SUBJECT: Waterford 3 SES
Docket No. 50-382
Informal Record of SQRT Audit

Please find enclosed a record of the Seismic Qualification Review Team audit for Waterford 3 SES.

LOUISIANA POWER & LIGHT
SEISMIC QUALIFICATION AUDIT

SUMMARY SHEET
AUGUST 30, 1982-SEPTEMBER 3, 1982

CHEMELEX		Chemelex Division Raychem Corporation 2201 Bay Road Redwood City, CA 94063
TYPICAL HEAT TRACING INSTALLATION		
VALVE BODY		
DETAIL	P-3	REV. 1

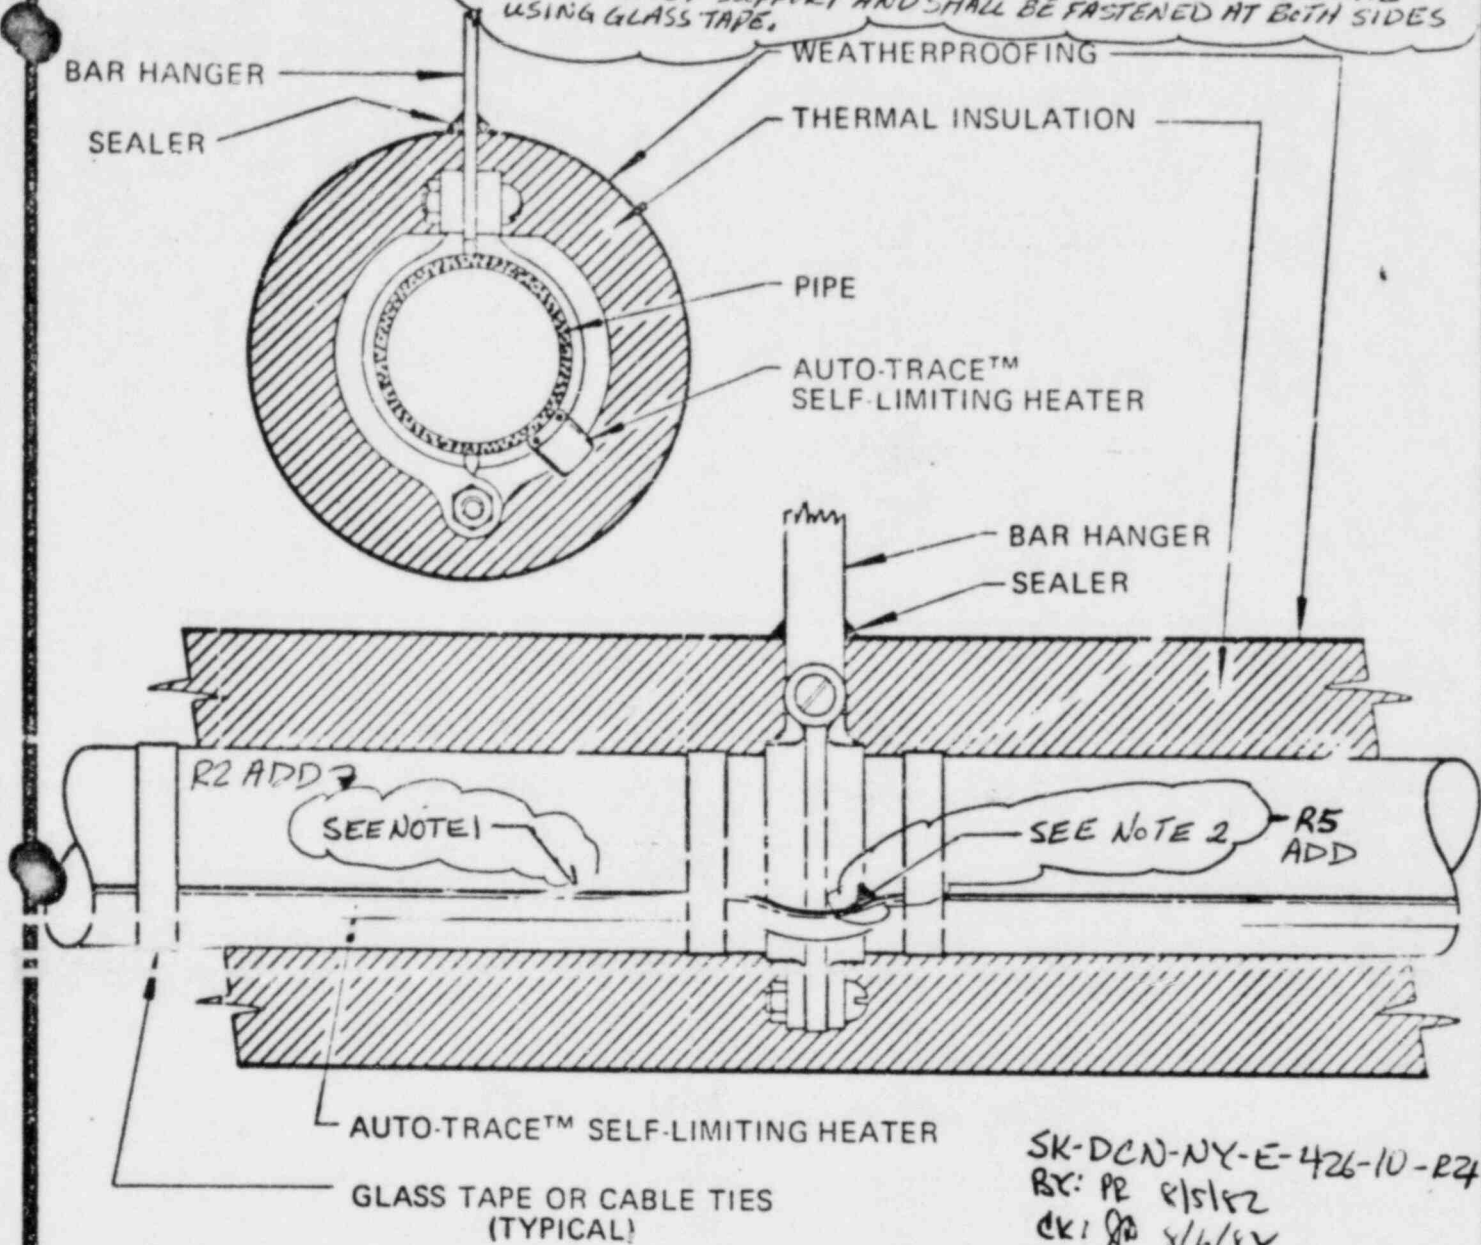
R5: THE NRC RAISED THE QUESTION OF HEAT TRACE CABLE POSSIBLY ~~BEING~~ BEING DAMAGED AT A BOX TYPE SUPPORT DURING A SEISMIC EVENT. IT WAS HYPOTHESIZED THAT IF THE HEAT TRACE CABLE WAS INSTALLED IN A TWISTED OR WRAPPED MANNER THROUGH SUPPORT IT COULD POSSIBLY BE SEVERED. SEE SKETCH 10 FOR RESOLUTION TO THIS POTENTIAL PROBLEM.

NOTES: (2) HEAT TRACE CABLE PASSING THROUGH "BOX TYPE" SUPPORTS SHALL BE INSTALLED FLAT ON PIPE AND PASS STRAIGHT THROUGH SUPPORT WITH NO TWISTING OR WRAPPING. CABLE SHALL BE KEPT AWAY FROM STRUCTURAL MEMBERS OF SUPPORT AND SHALL BE FASTENED AT BOTH SIDES USING GLASS TAPE.

PROJECT: WATERFORD III SES OPS NO. FIELD CHANGE NO. FCR-IC-P-451

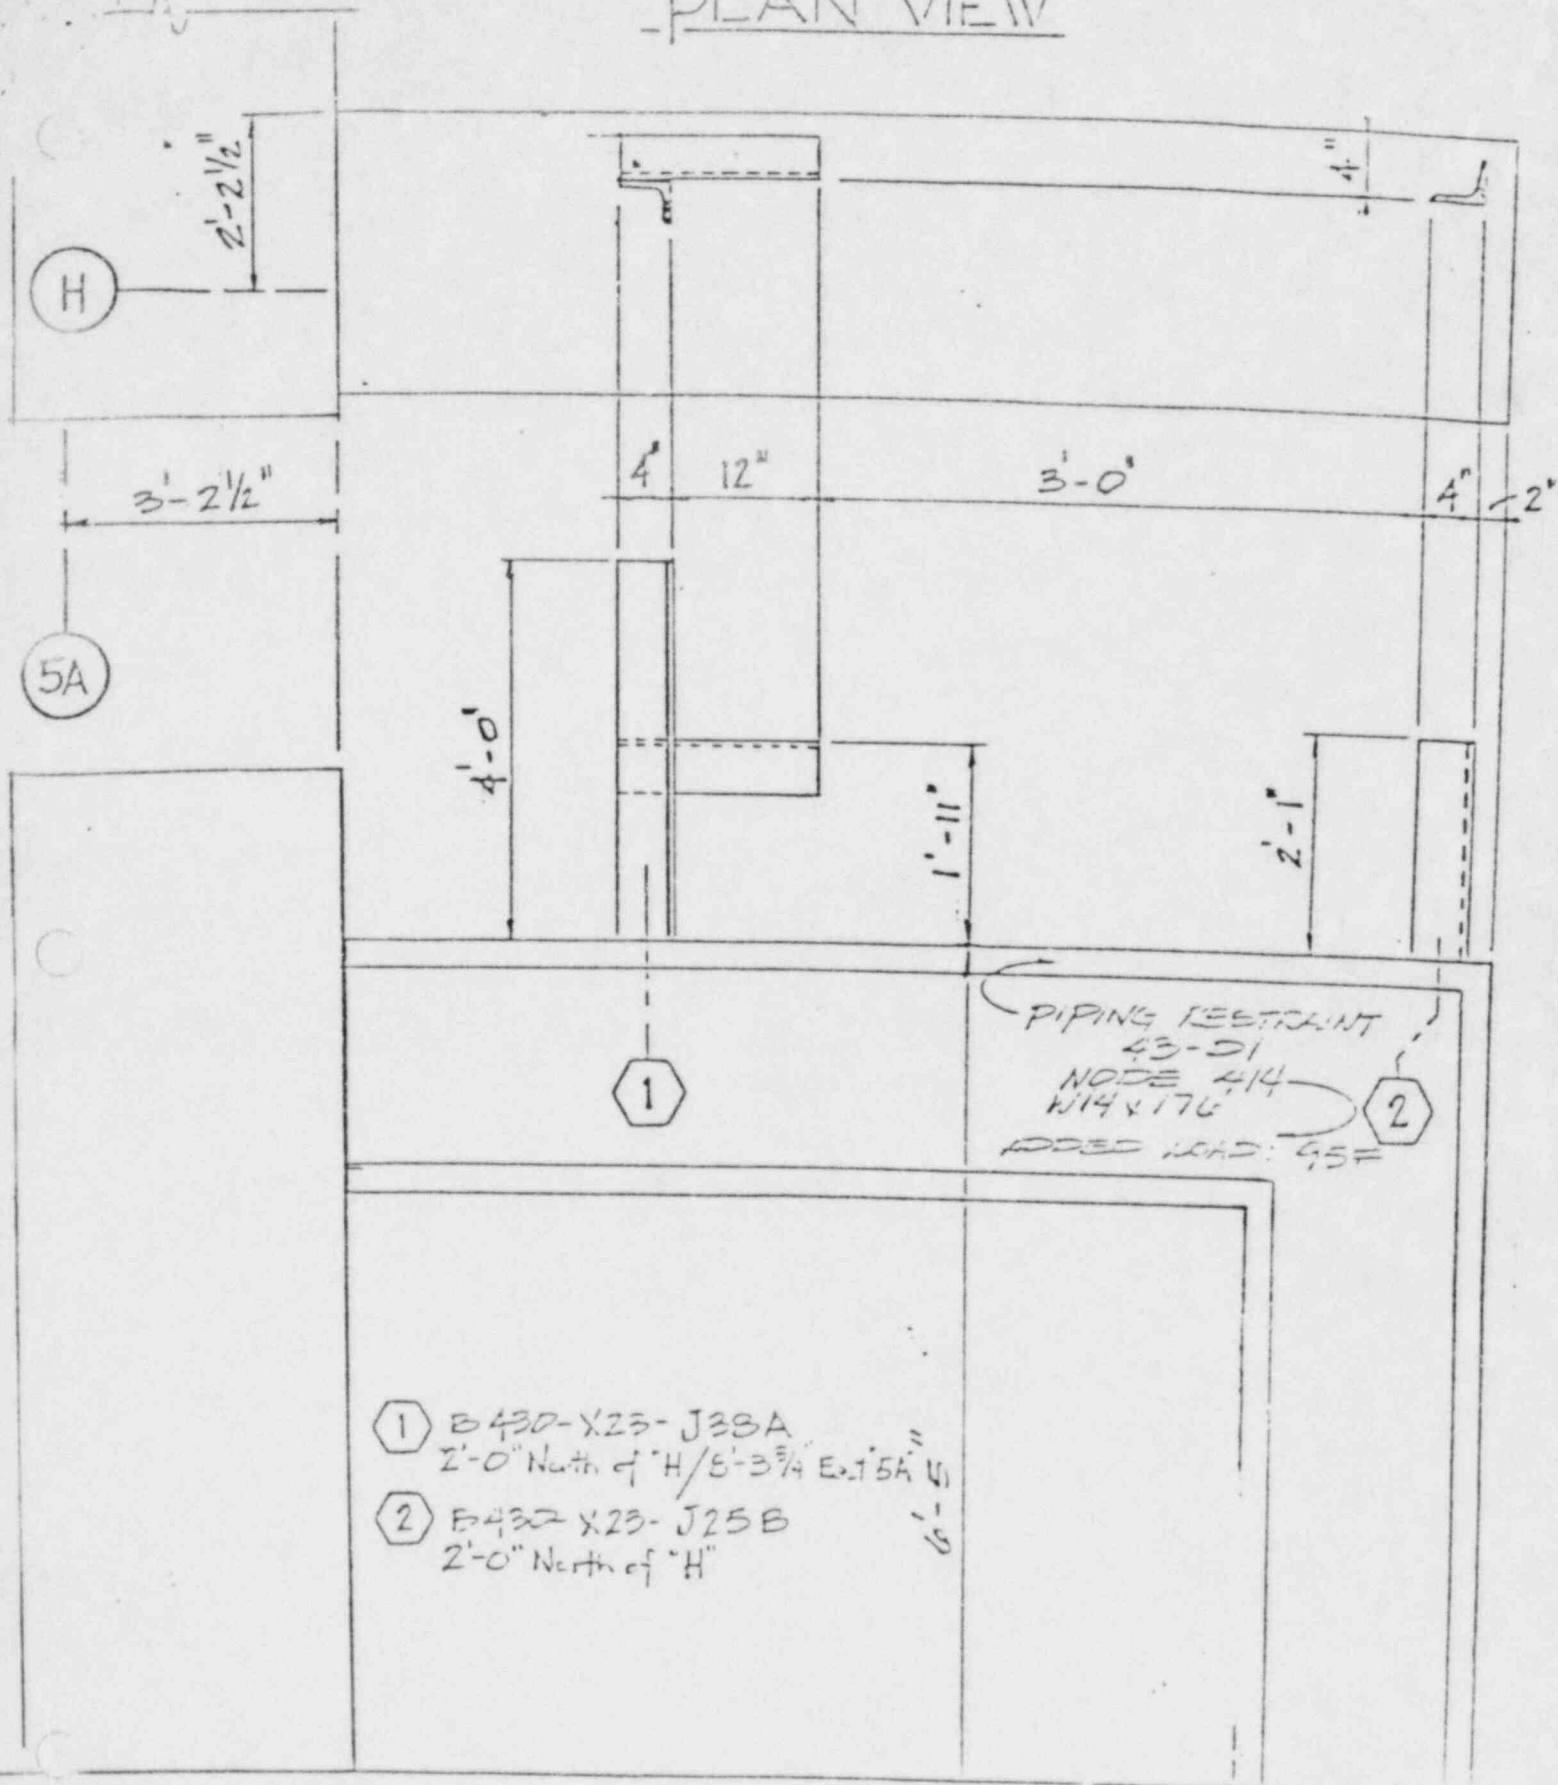
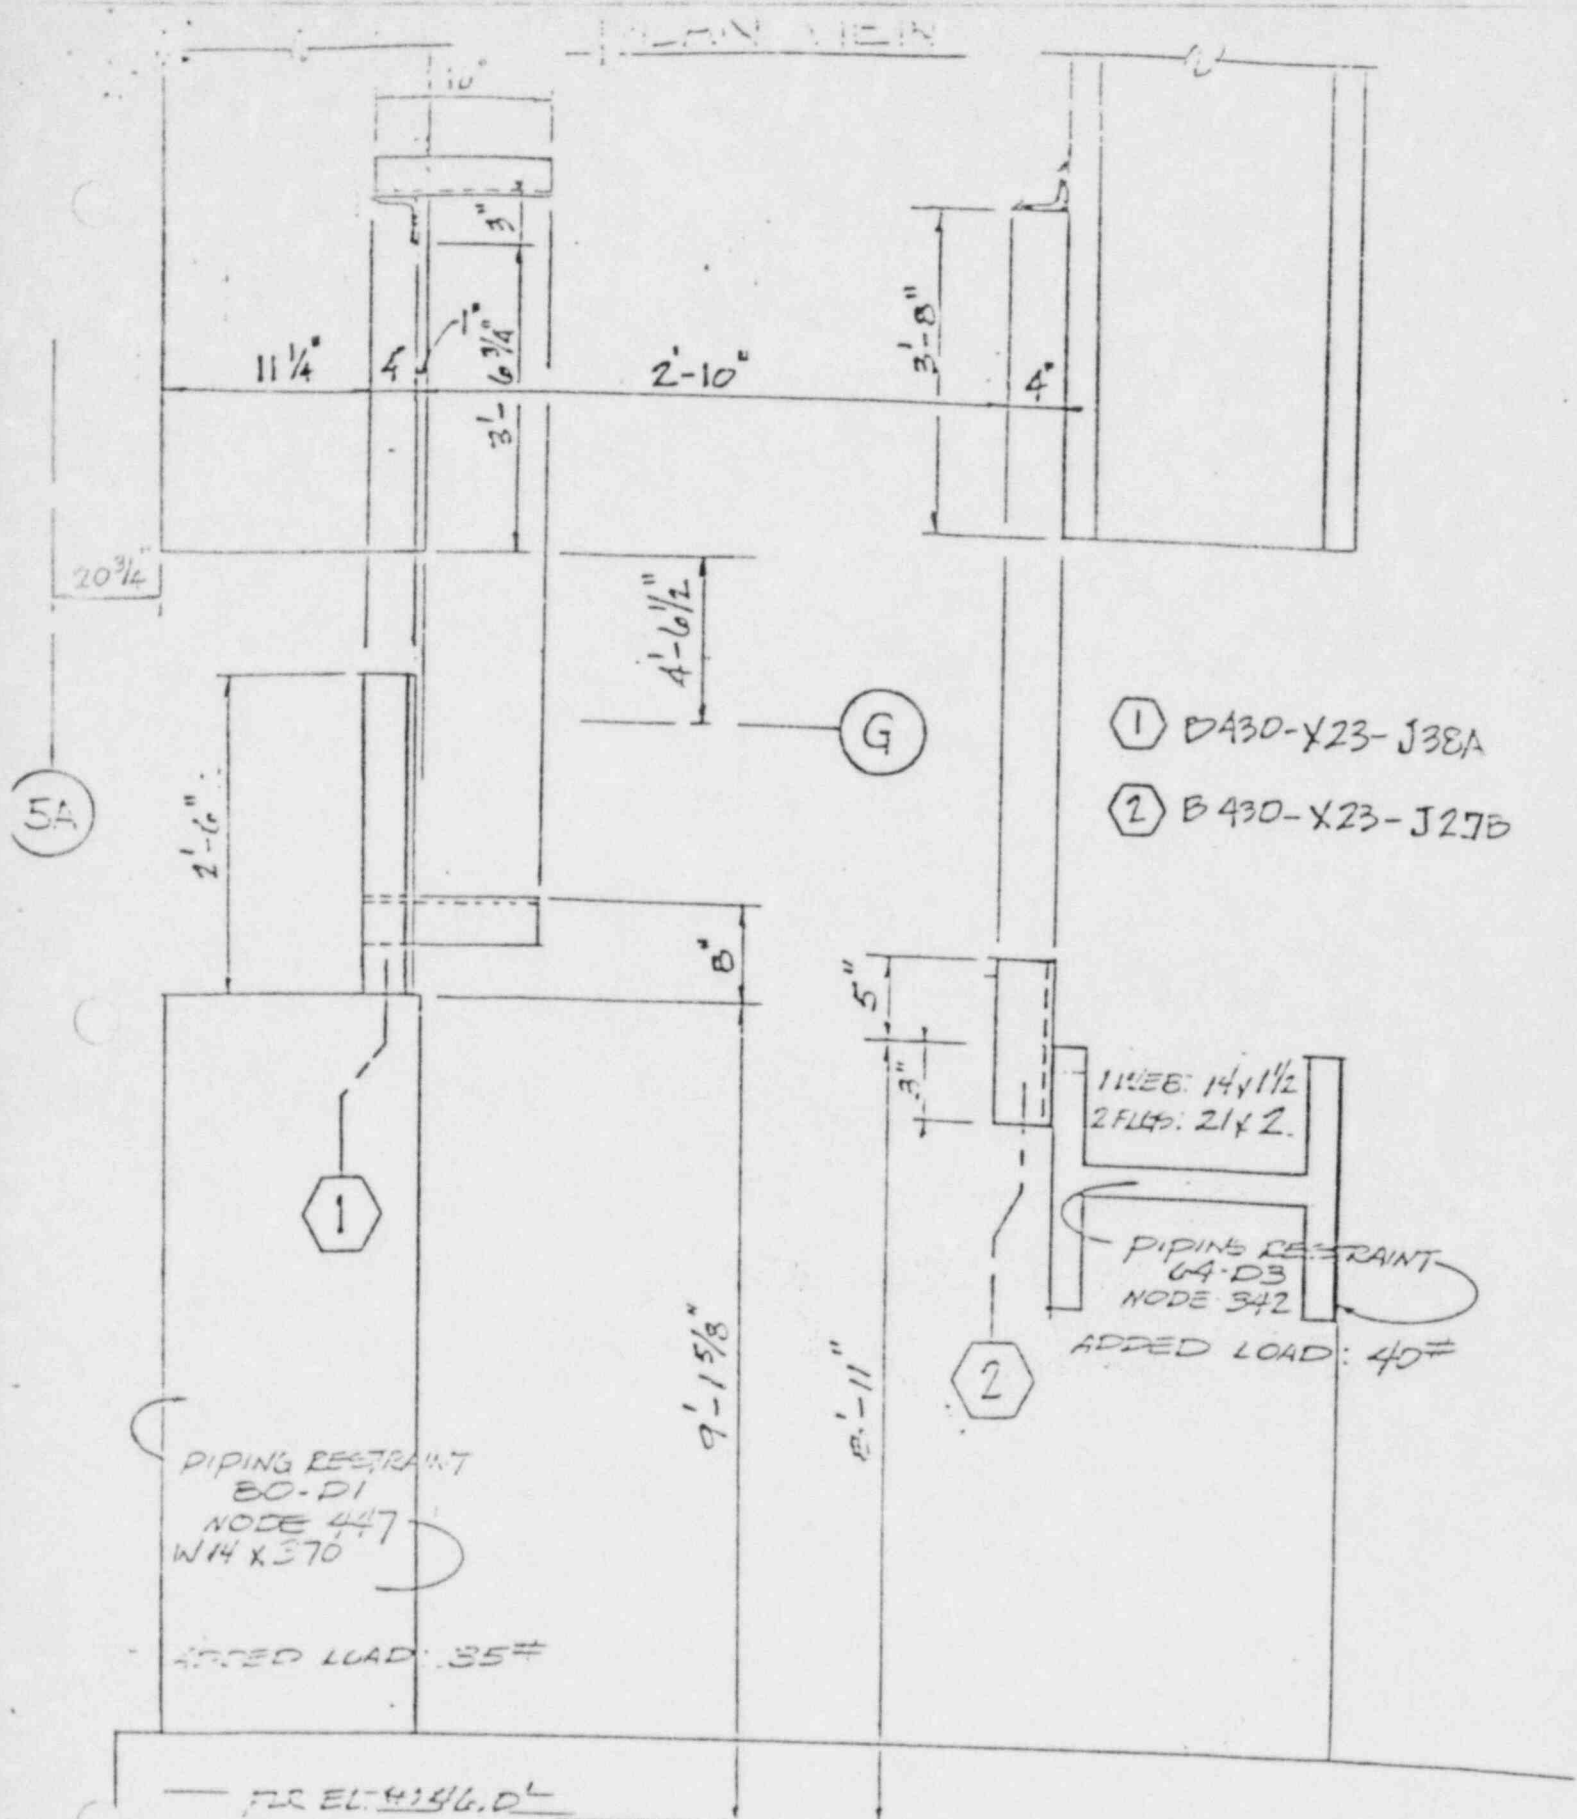
1. DESCRIPTION (Items involved, submit sketch if applicable)
TUBE TRACK SUPPORTS FOR INSTRUMENT AIR INSTALLATION TO CONTROL VALVES SFV-FM-833 AND SFW-FM-834, SUS 72A.

4. RECOMMENDED DISPOSITION (Submit sketch if applicable) [x] Minor Change [] Major Change
ATTACH TUBE TRACK SUPPORT X23-J38A AND X23-J25B TO PIPING RESTRAINT #43 DI NODE # NODE 414-W14X176. ATTACH TUBE TRACK SUPPORT X23-J38A TO PIPING RESTRAINT #80 DI NODE 447 W-14X370. ATTACH TUBE TRACK SUPPORT X23-J27B TO PIPING RESTRAINT # 64 D3 NODE 342. TOTAL OF 4 SUPPORTS - SEE ATTACHED SKETCHES

SUBJECT SUPS Panel Seismic Bolting

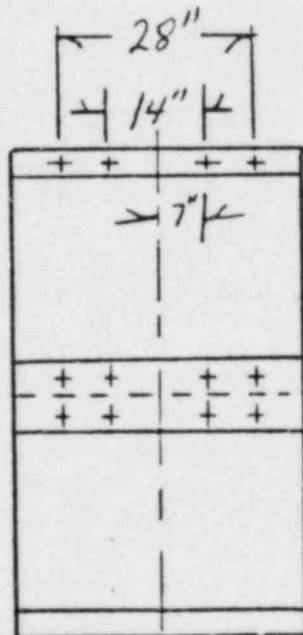
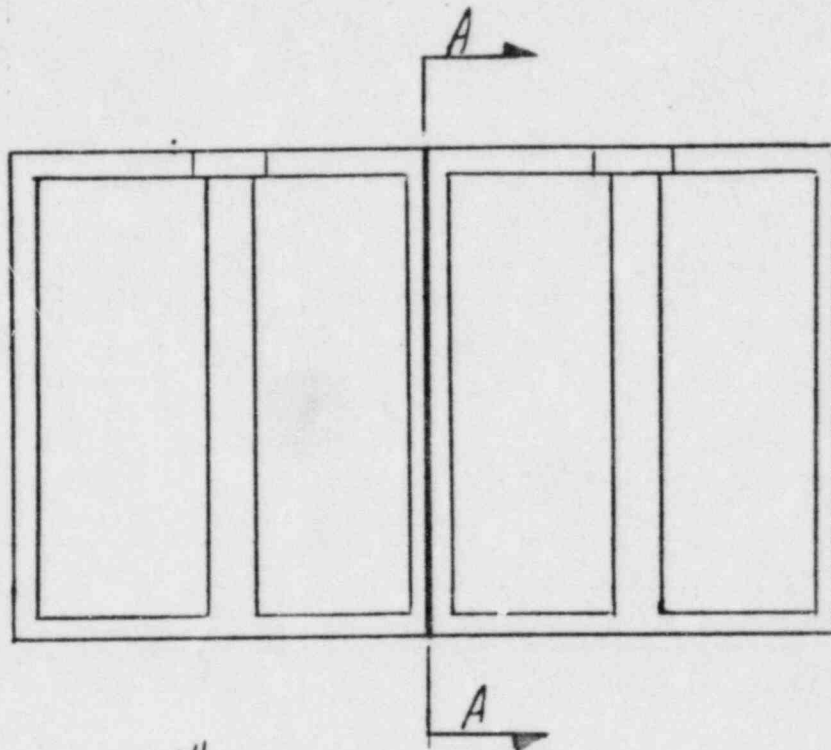
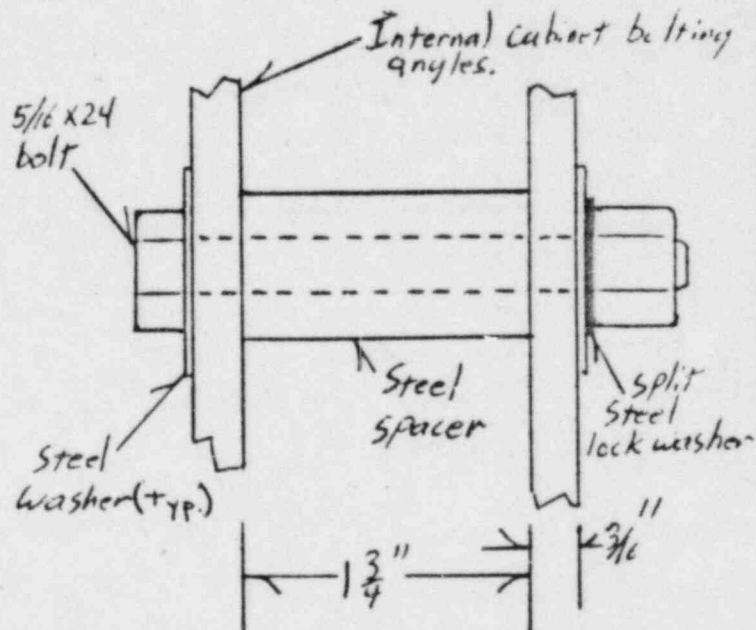
Field Change Request (FCR No. _____)
 Required modifications to design or specification
 Disposition of nonconforming item
 Changes in regulatory or other requirements
 Operational experience
 Other To upgrade seismic capability of SUPS panels
